## ADDENDUM NO. 02

Date of Issuance: January 24, 2025

Project: **2024 Cypress Falls HS Renovation**  
Cypress-Fairbanks Independent School District

Texas Arcadis Inc.  
Project No.: 202318

1 GREENHOUSE  
1/4" = 1'-0"

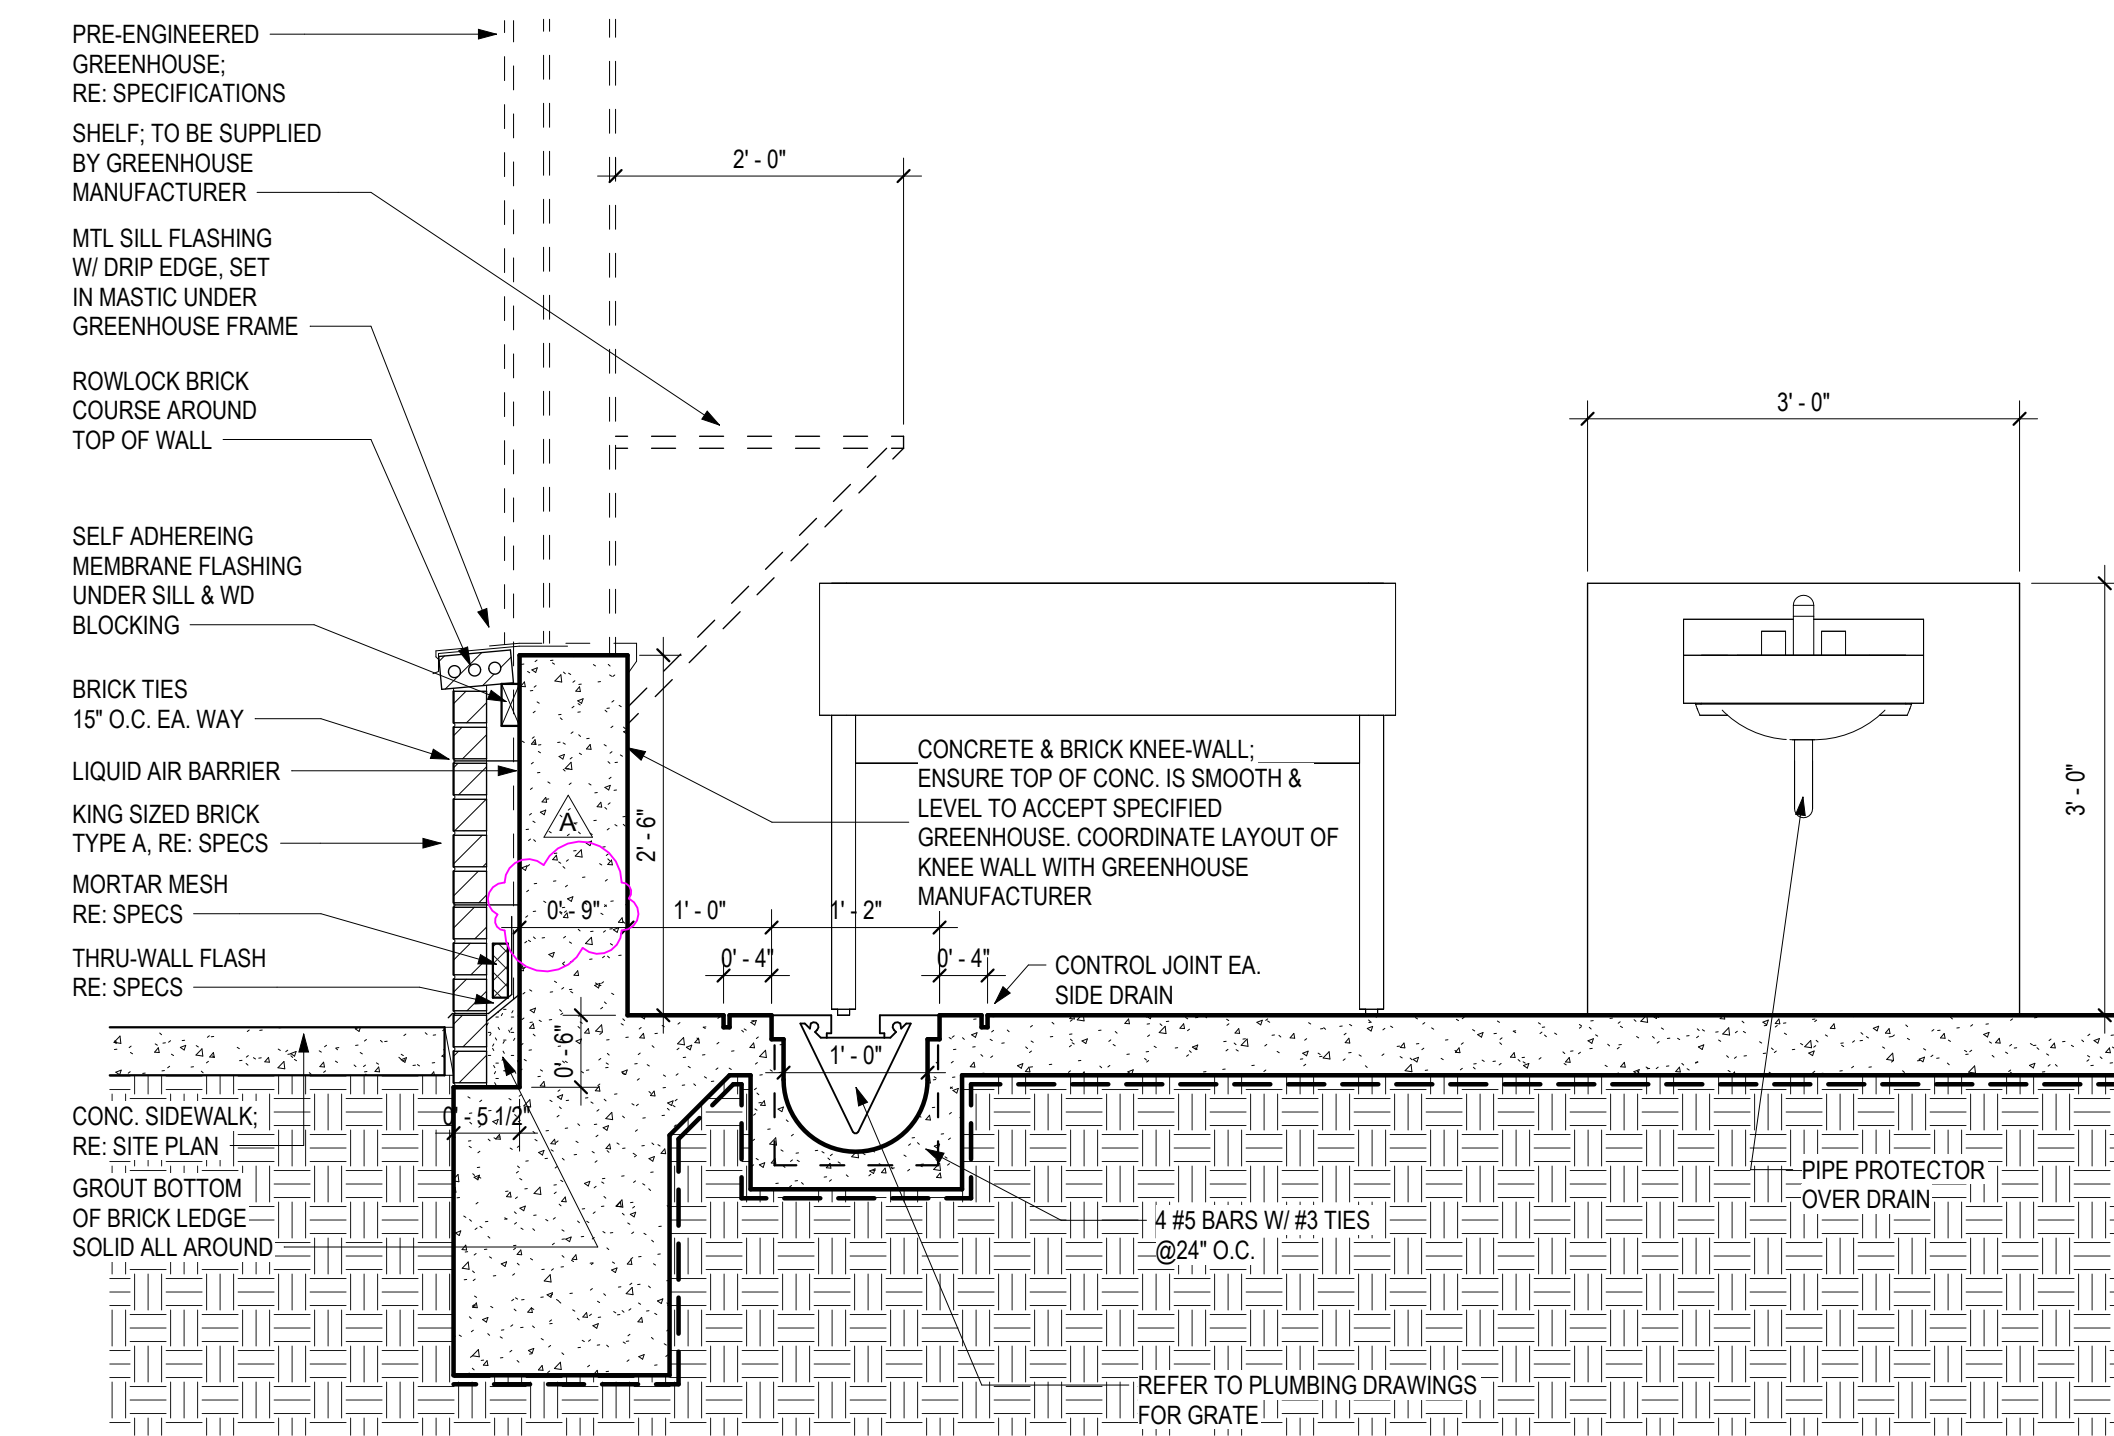
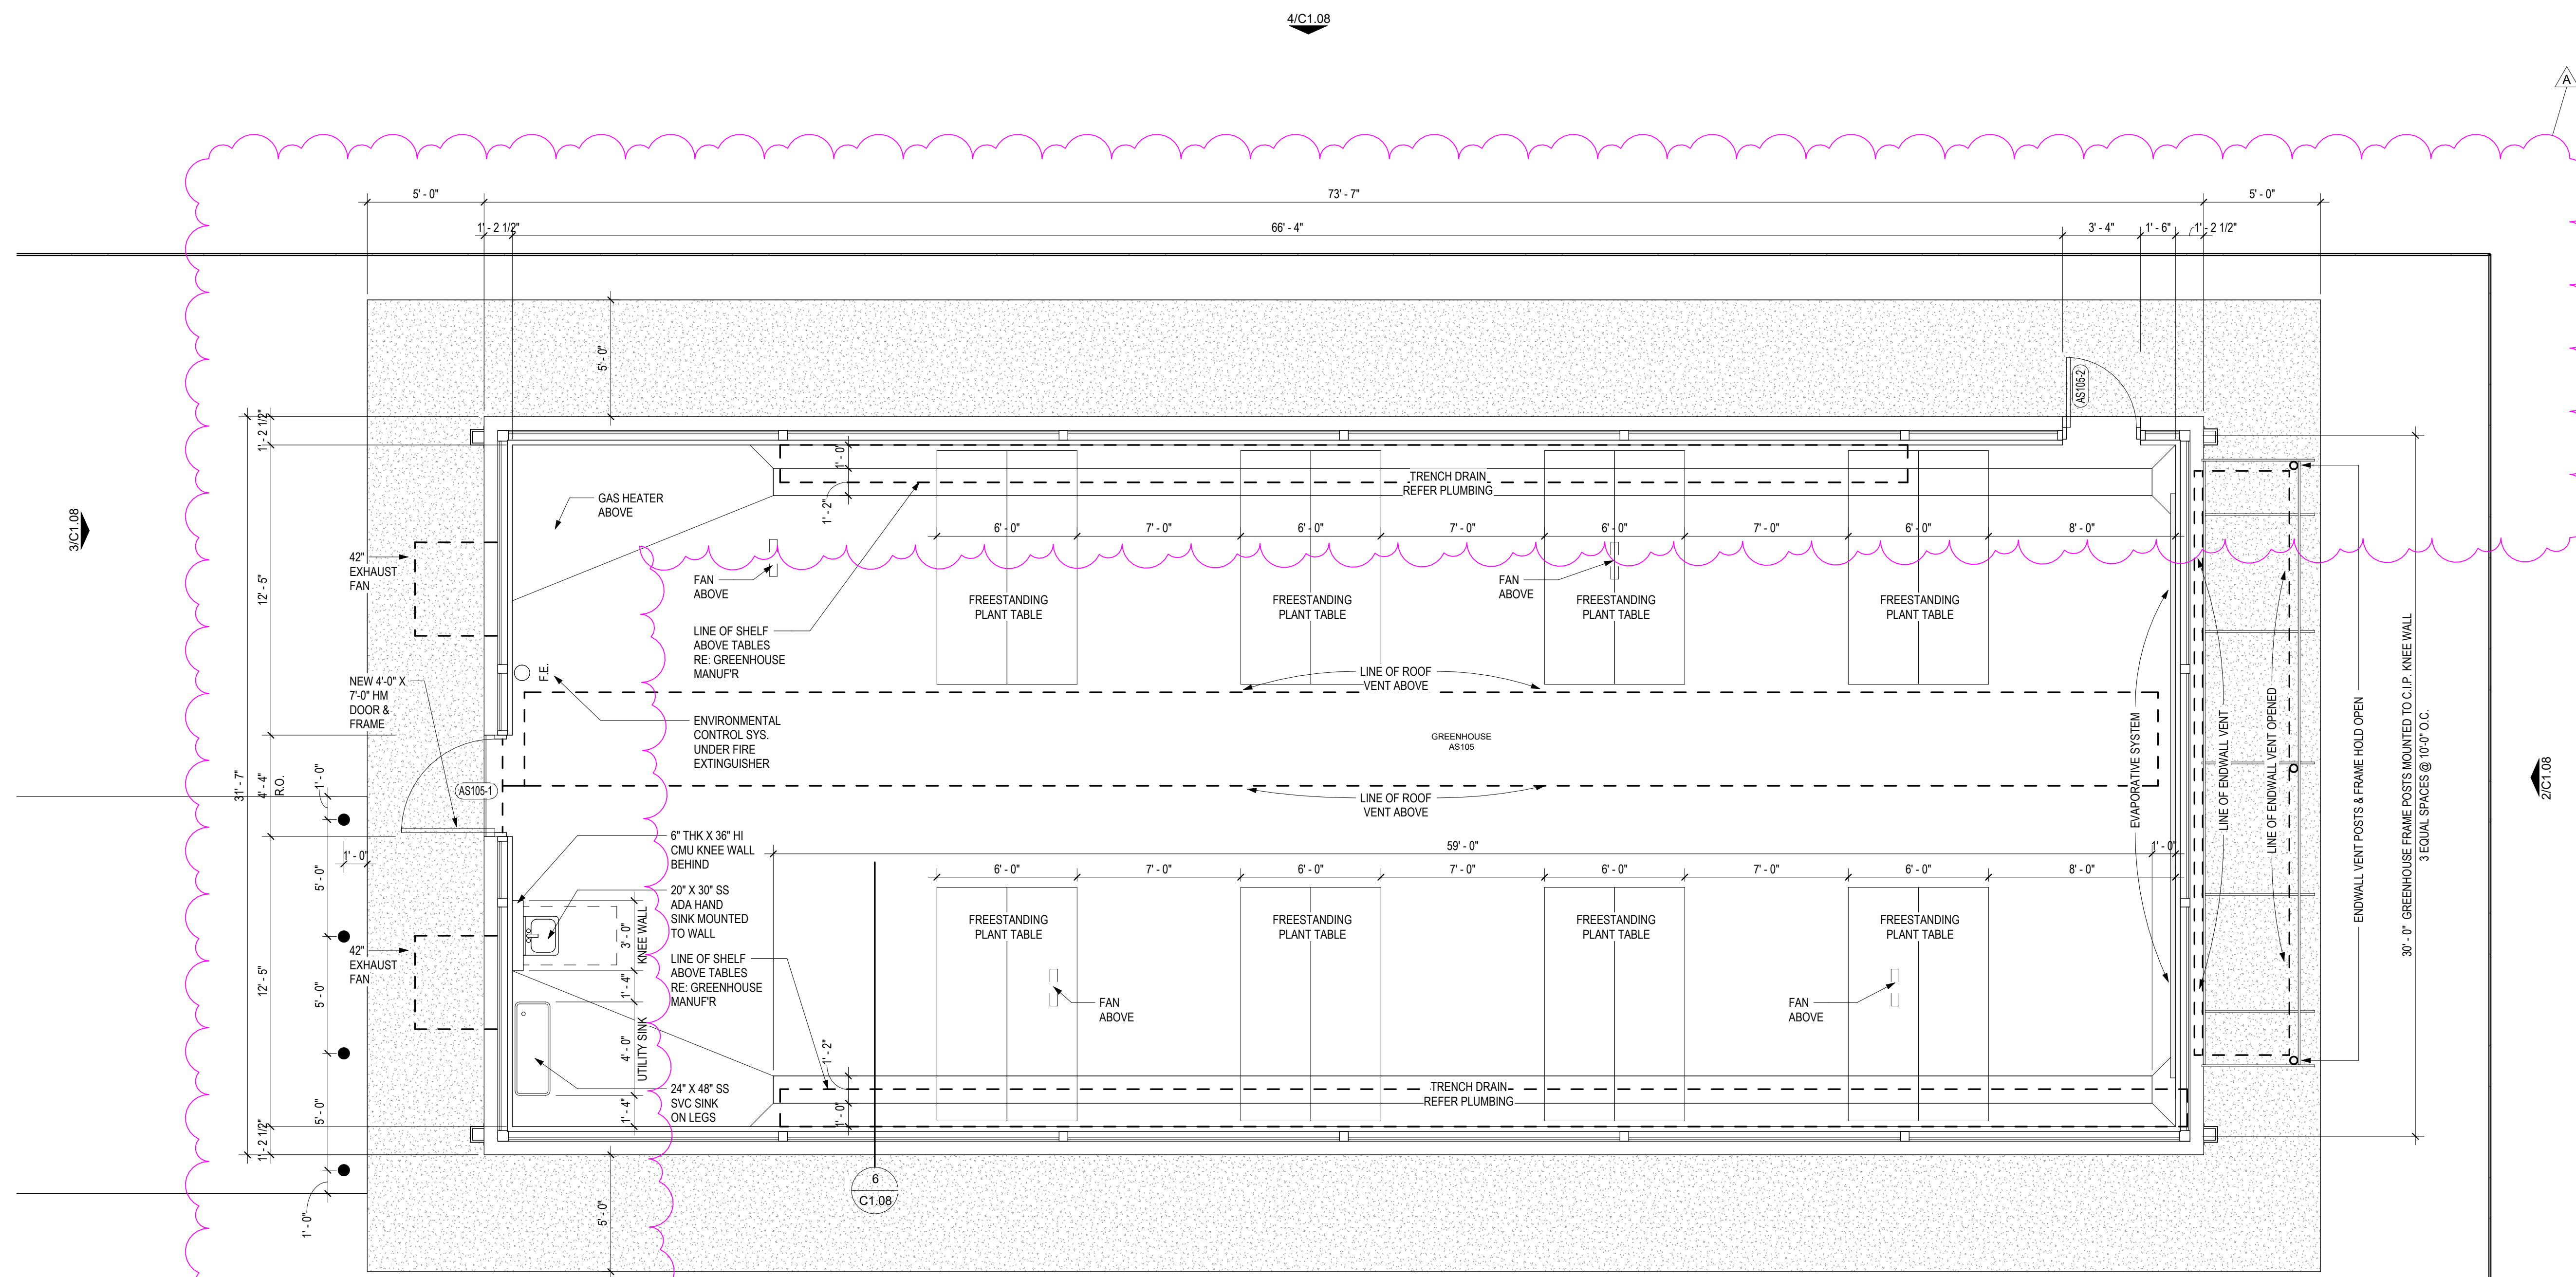
32. Sheet C1.08 - ENLARGED SITE PLAN – GREENHOUSE
  - a. Dimensions regarding the thickness of concrete knee wall have been revised on details 1 and 6. Provide additional dimensions to paving.

**1 AREA 'G1' - 1ST FLOOR PLAN**  
1/8" = 1'-0"

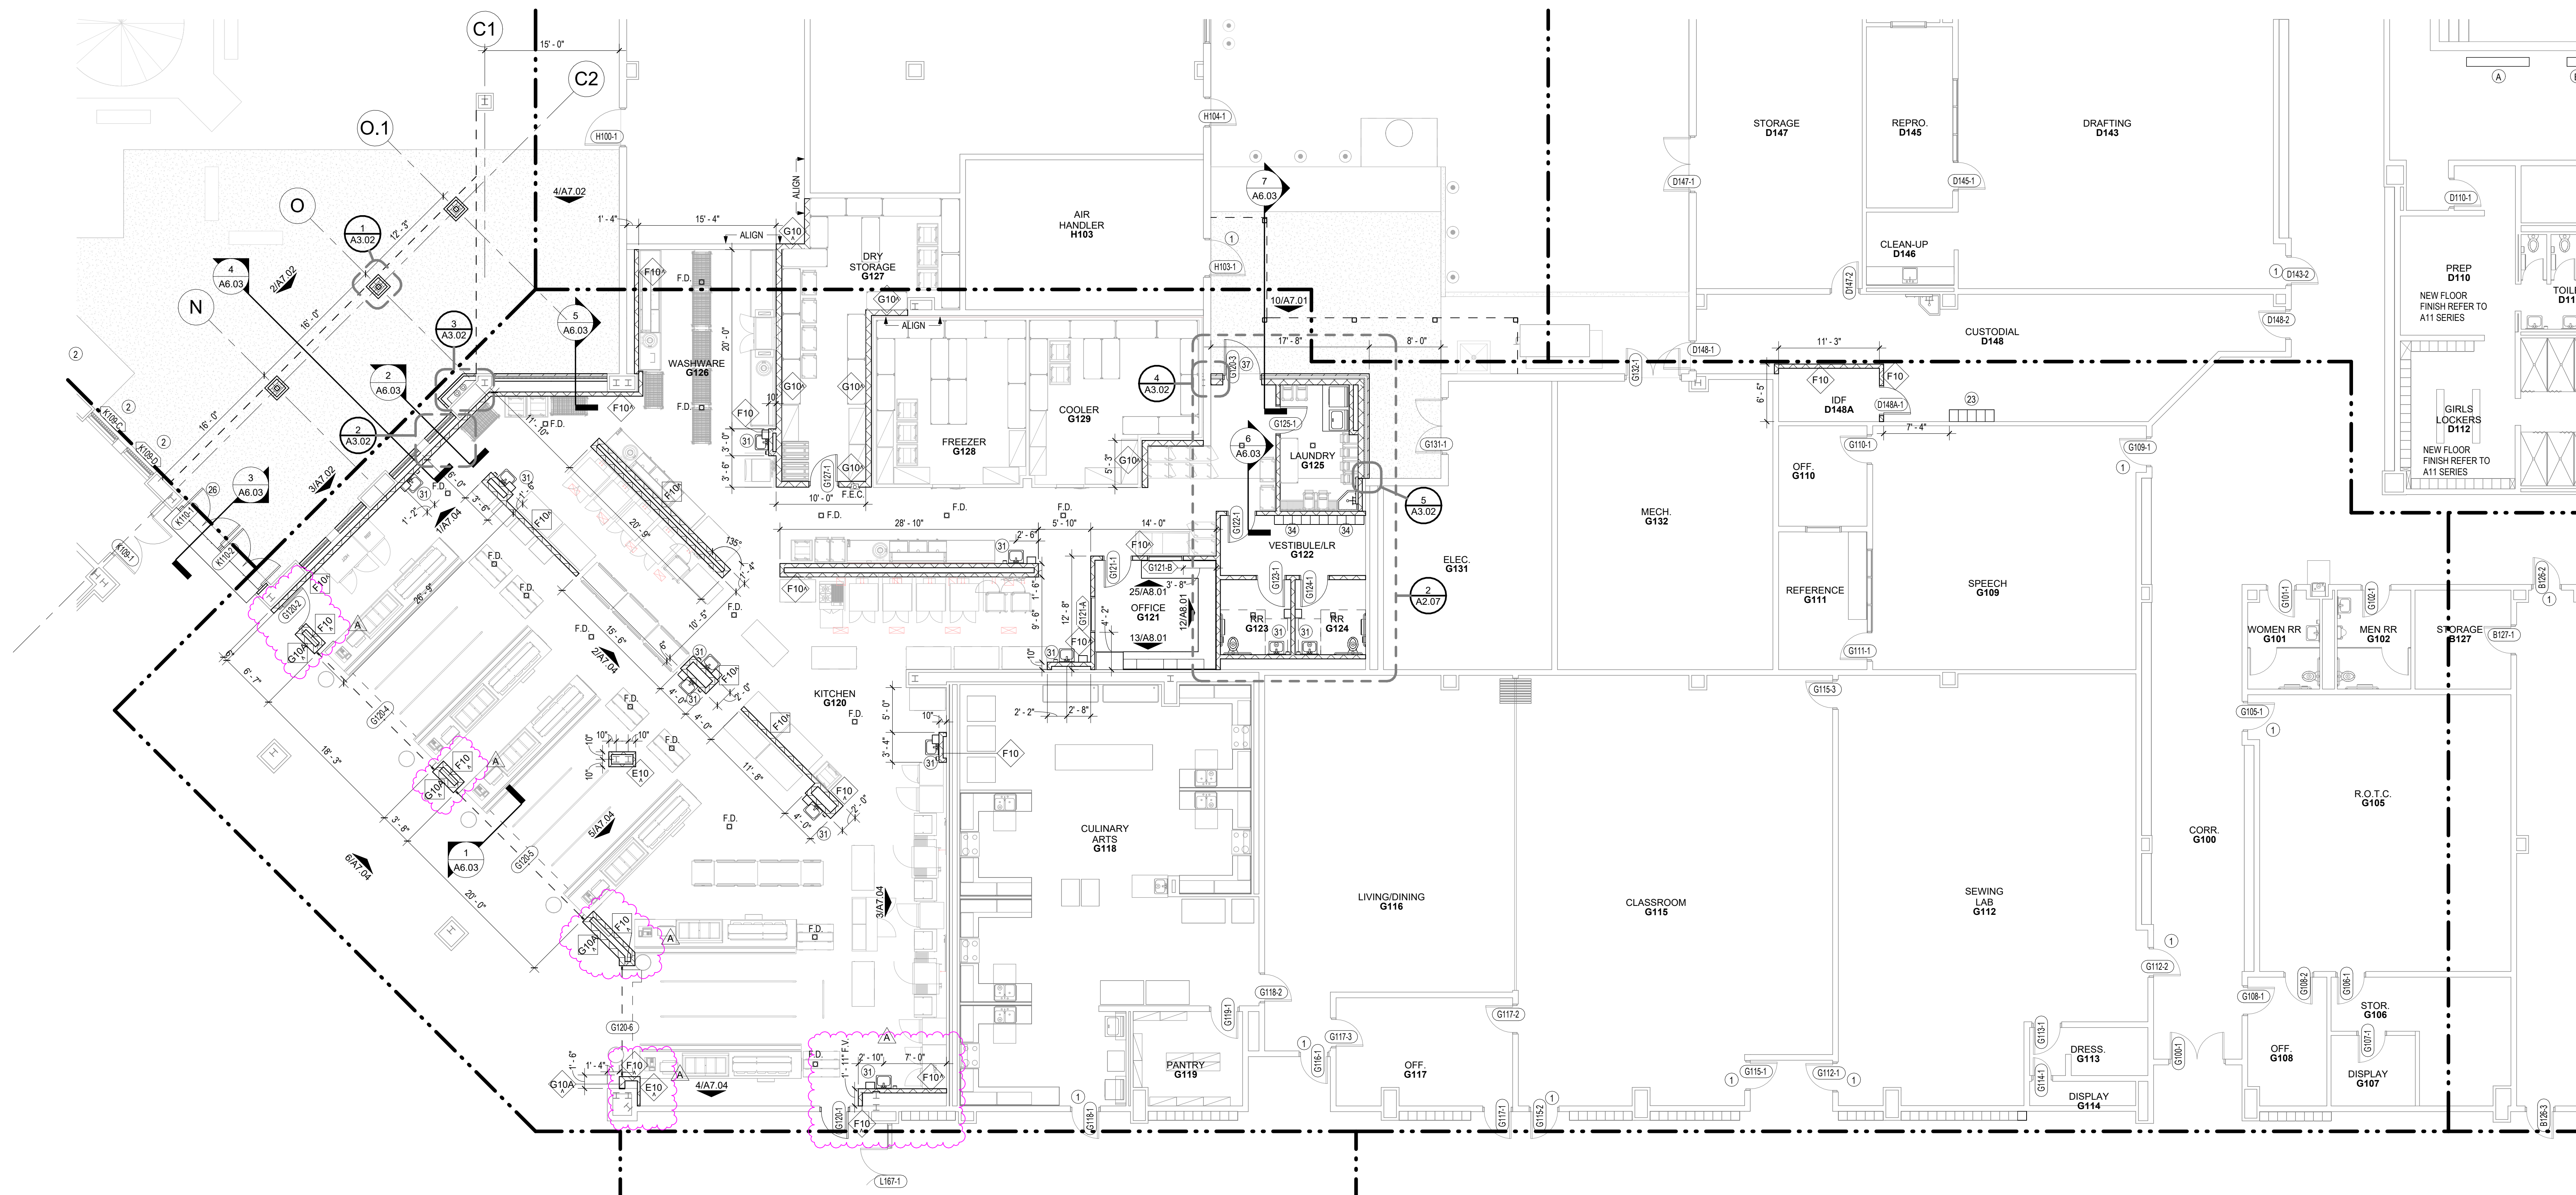
38. Sheet A2.07 – AREA 'G1' 1<sup>ST</sup> FLOOR PLAN
- a. Added 6" CMU column wraps at the overhead coiling door openings of the kitchen area G120. Add "^" to indicate curb at this wall.

- b. Removed detail 3.
  - c. Revised reference detail on Notes – General Floor Plan, note 24 to say "RE: STRUCT."
  - d. Revise keynote 4 in the keynote- floor plan legend.

- e. Revised the 4" fur out to be 6" CMU (F10^).
39. Sheet A2.14 - AREA 'P1' 1<sup>ST</sup> FLOOR PLAN
- a. Removed keynote 29 from room P109.
  - b. Revised reference detail on Notes – General Floor Plan, note 24 to say "RE: STRUCT."
